PRELIMINARY OVERALL AREA DEVELOPMENT PLAN

VENTANA OAKS

RE: Revised Ventana Oaks (Centre Park North) Subdivision POADP #414

RE: Centre Park North Subdivision POADP #414

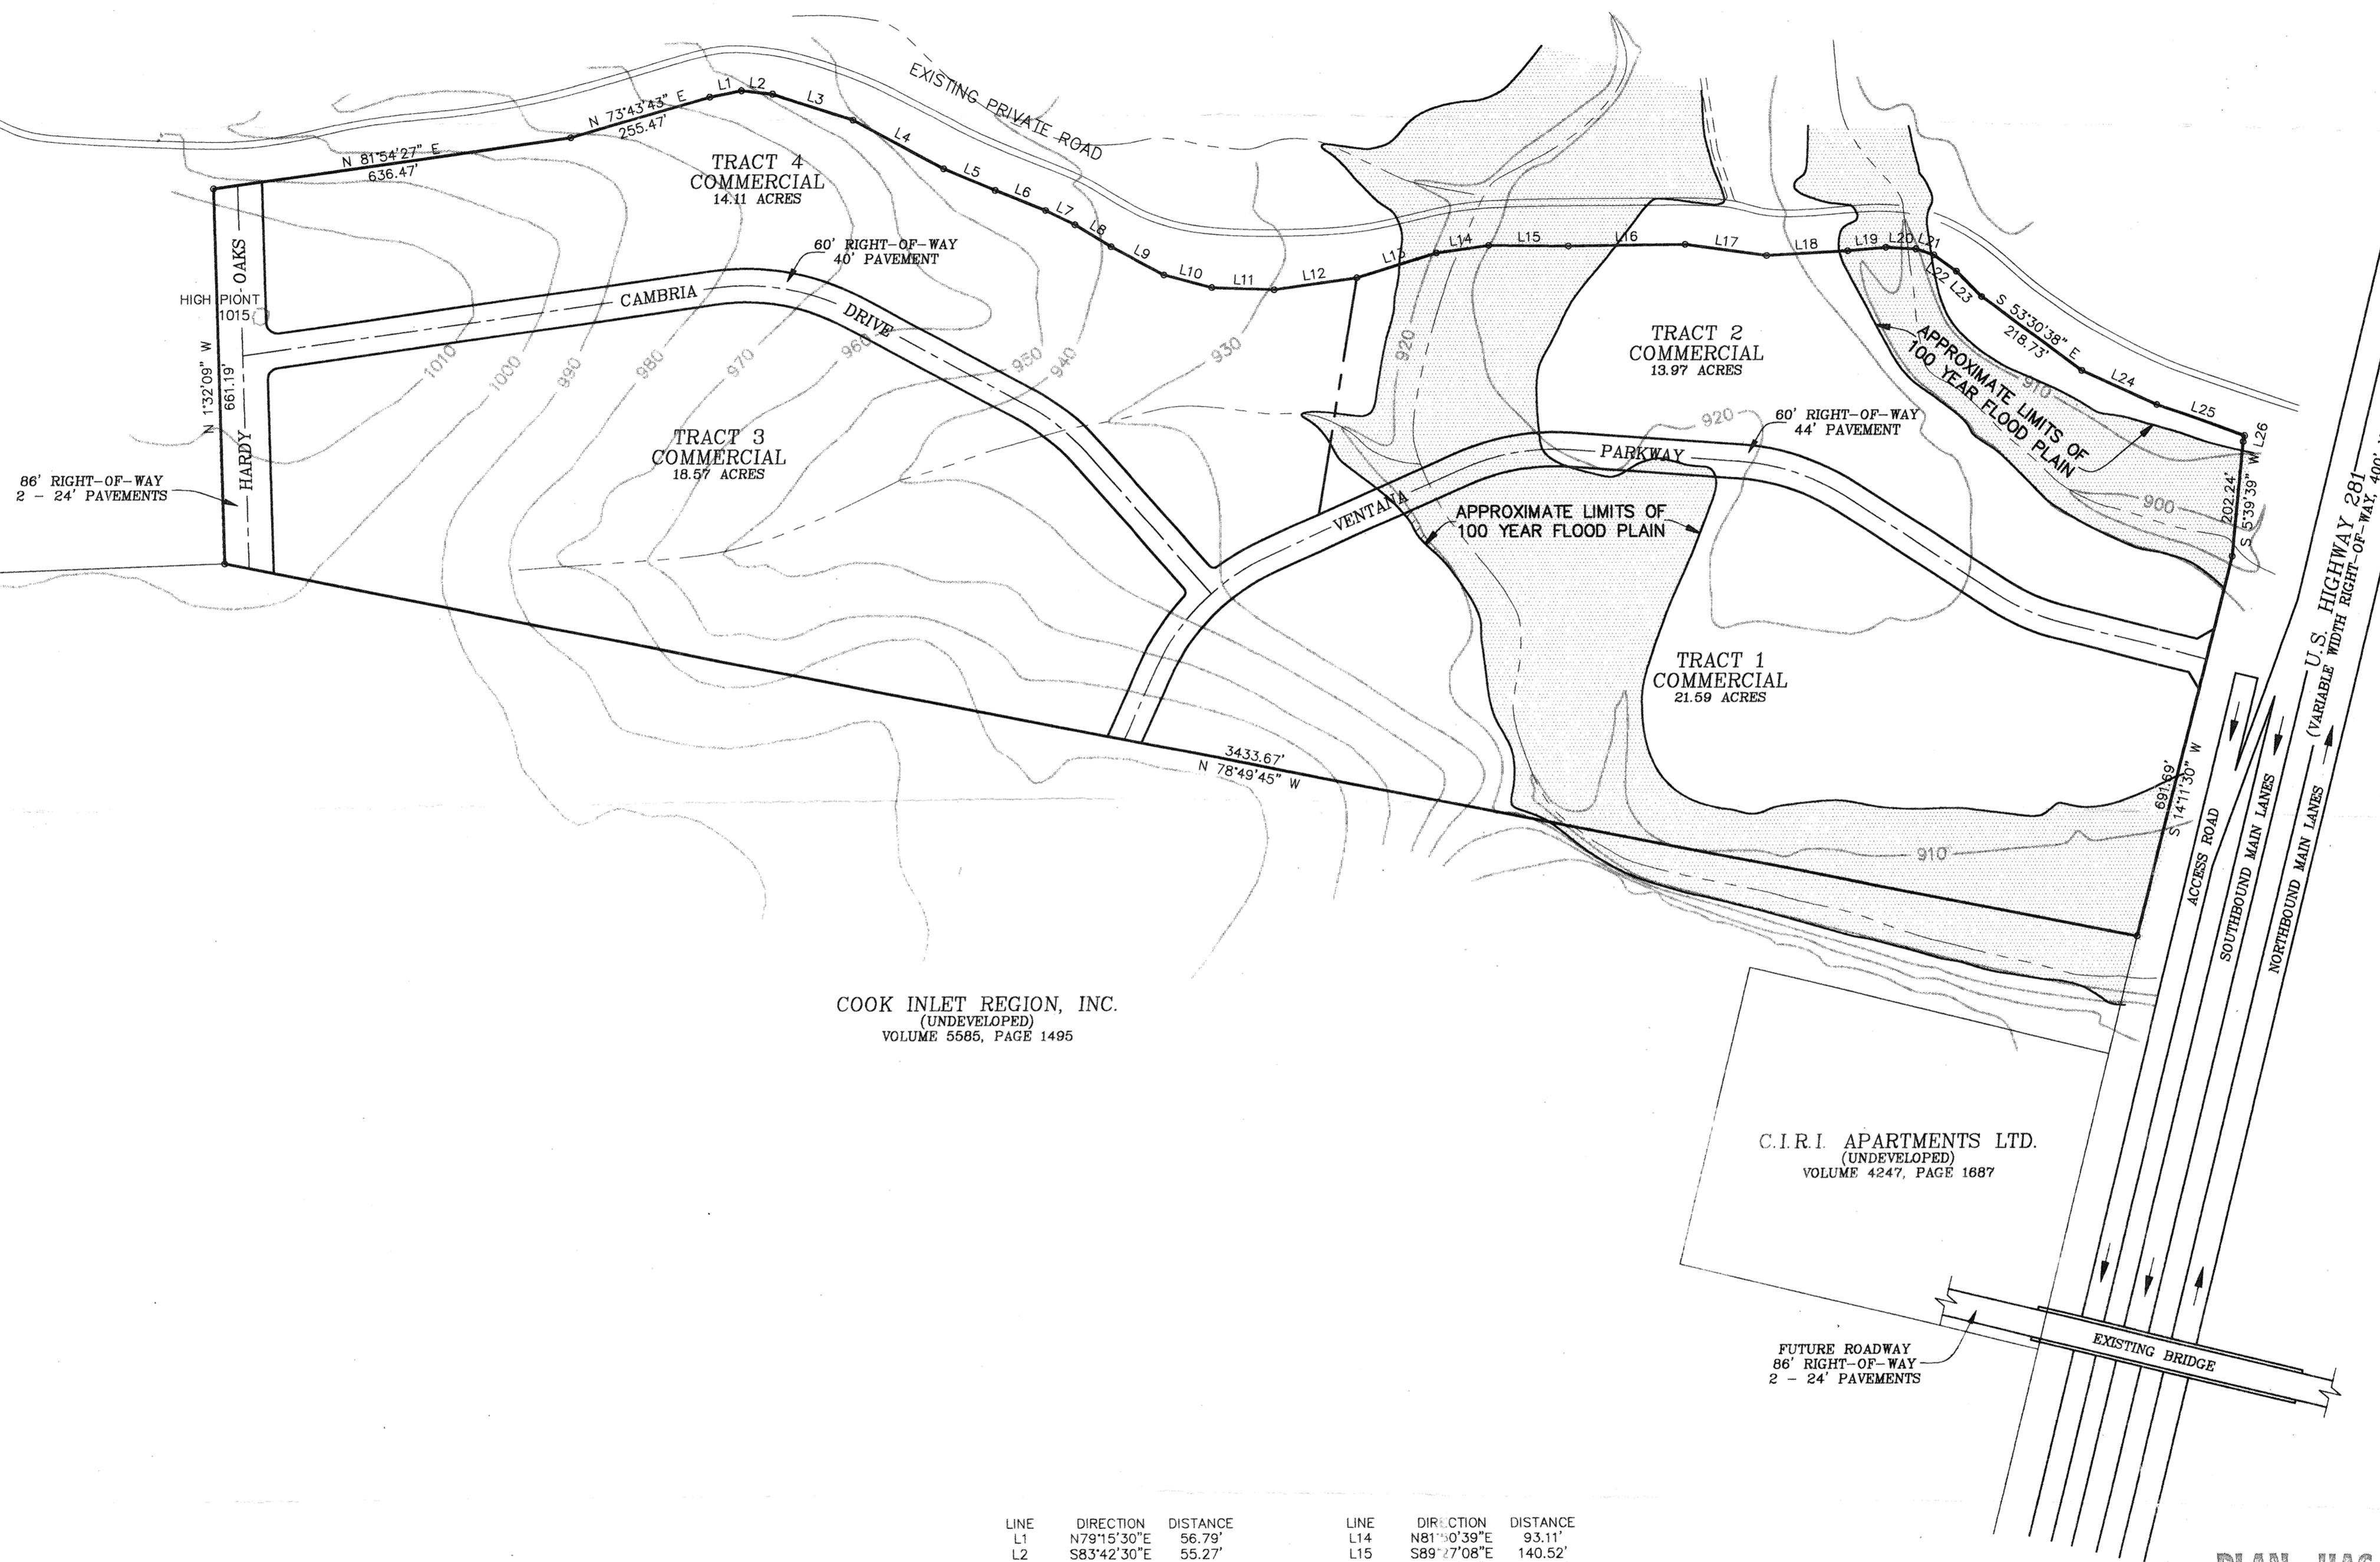
The City Staff Development Review Committee has reviewed your Centre Park North Subdivision Preliminary Overall Area Development Plan #414. However, your plan was not accepted for the following reasons:

1. Hardy Oaks must be platted, dedicated, and constructed at full 86 feet of ROW in conjunction with any adjacent plat unit submitted.
2. The Traffic Planning Engineer has indicated that the schematics for U.S. 281 North appear to represent proposed and not existing design.

The City Staff Development Review Committee has reviewed your revised Ventana Oaks (Centre Park North) Subdivision Preliminary Overall Area Development Plan #414. Please find enclosed a signed copy for your files. You may now submit individual subdivision plat units at your convenience. As shown on your plan, Hardy Oaks will need to be platted, dedicated, and constructed with the first subdivision unit encompassing or adjacent to the Hardy Oaks ROW. Additionally, your access point on U.S. 281 North is subject to final approval in writing from the Texas Department of Transportation during subdivision plat review.
